FINAL PRODUCT/PROCESS CHANGE NOTIFICATION
Generic Copy

SUBJECT: ON Semiconductor Final Product/Process Change Notification #16141

TITLE: 1N5388 and Similar Data Sheet Updates

CHANGED PART IDENTIFICATION:

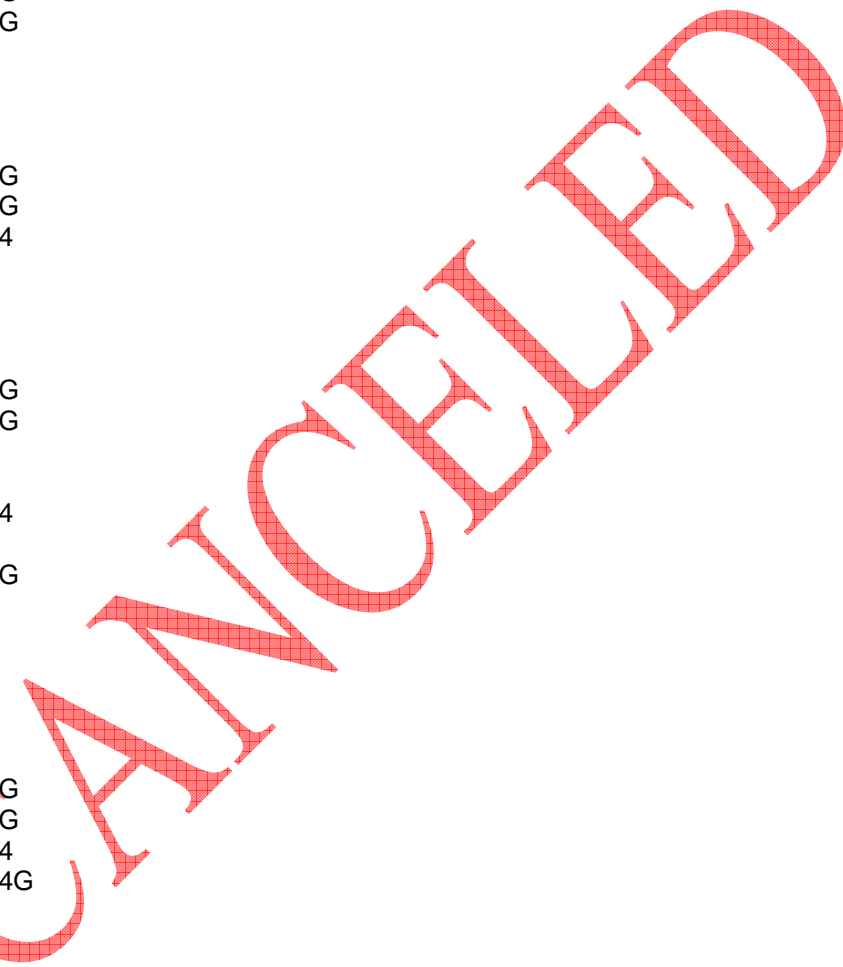
ON Semi is issuing this notification to address a data sheet revision. The current data sheets identify an Operating and Storage Temp range of either 175C or 200C maximum and ON Semi is re-stating that temperature to be 150C. The reason for this data sheet update is to prevent mis-application of the devices. There will be no change to the actual product. The data sheets contain an application note for calculating junction temp.

There will be no change to the parts and this is only a data sheet update.
